# TECHNICAL INFORMATION

Range <b>SLIF</b>	Model <b>7xxx range</b>	T.I. Nr <b>06_2012</b>
Serial Number <b>14911292</b>	Subject <b><u>NEW EXPANSION BOARD</u></b>	Complaint Nr <b>N/A</b>

## NEW EXPANSION BOARD ( SPARE **F00172** )

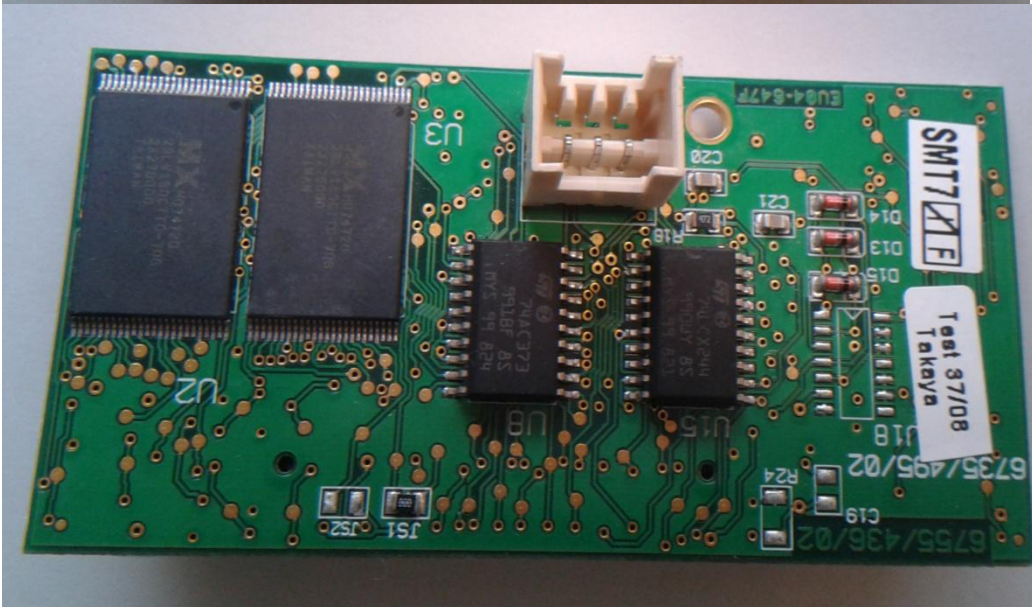
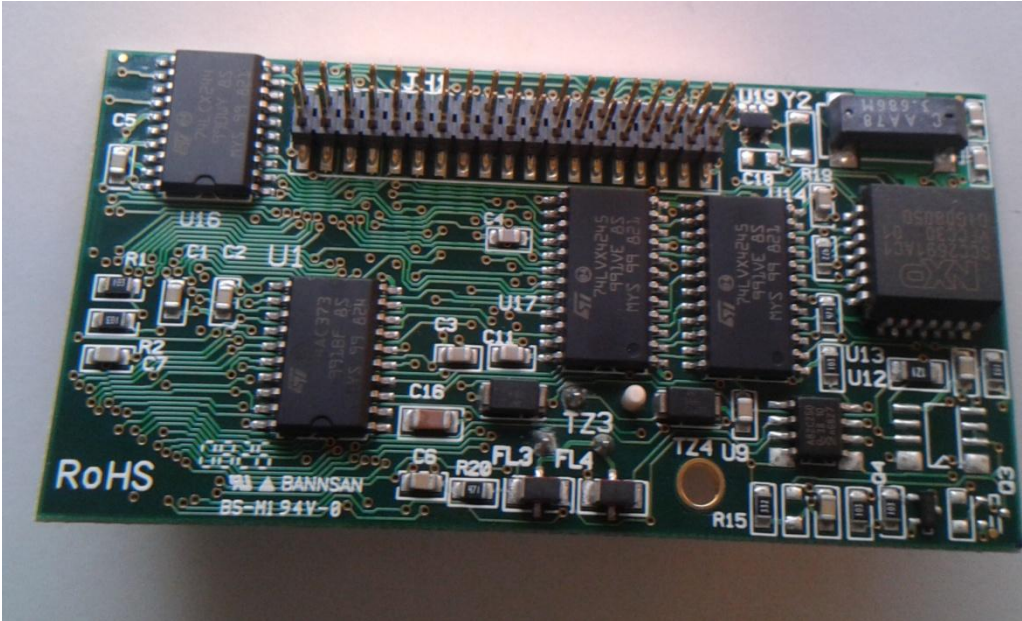
The difference between 01 and 02 CPU board revisions can be detected of course by the label with the CPU revision code.

Can be also optically recognized looking to the expansion board.

1) 6735495 02 (3V3 witout any modification); CPU 673202800, 673202900

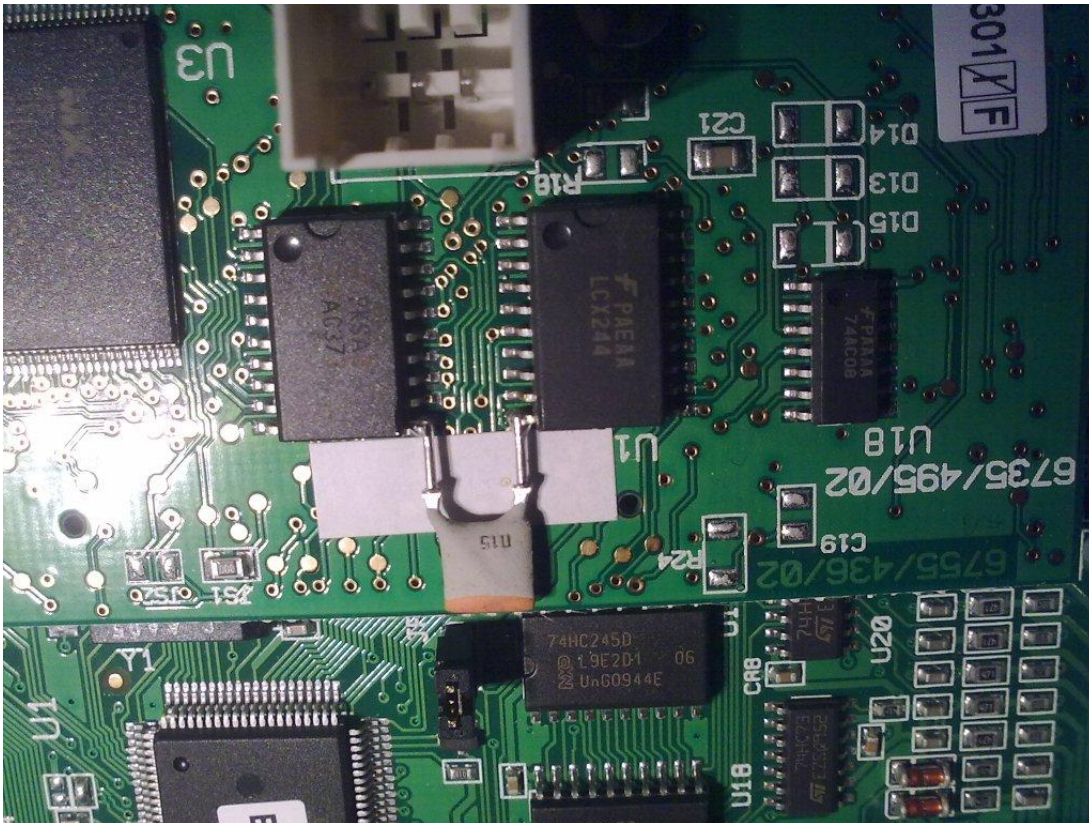
Various level shifter ICs on the back and rev 02 on the top silk screen can be used to recognize this expansion board version.

2) 6735495 03 (3V3 with added capacitor); CPU 673202801, 673202901

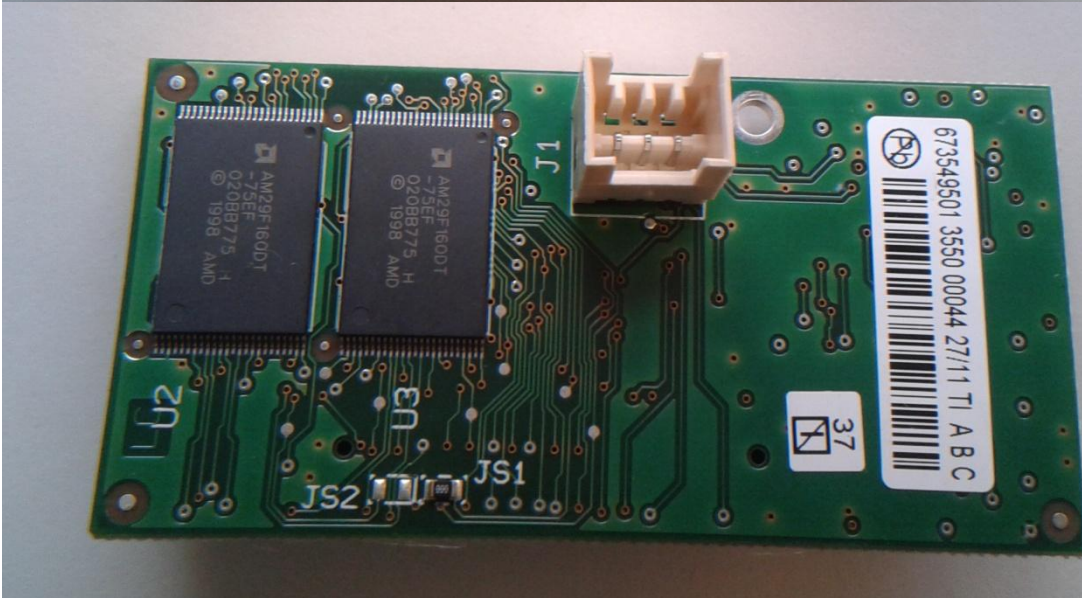
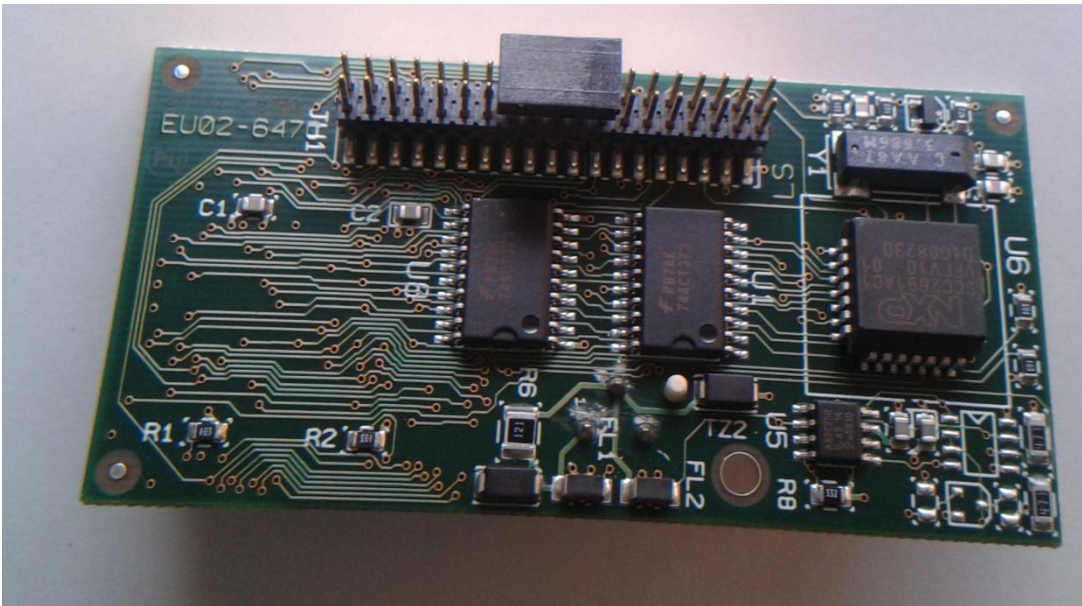
An added capacitor is visible between U8 and U15 of expansion board.
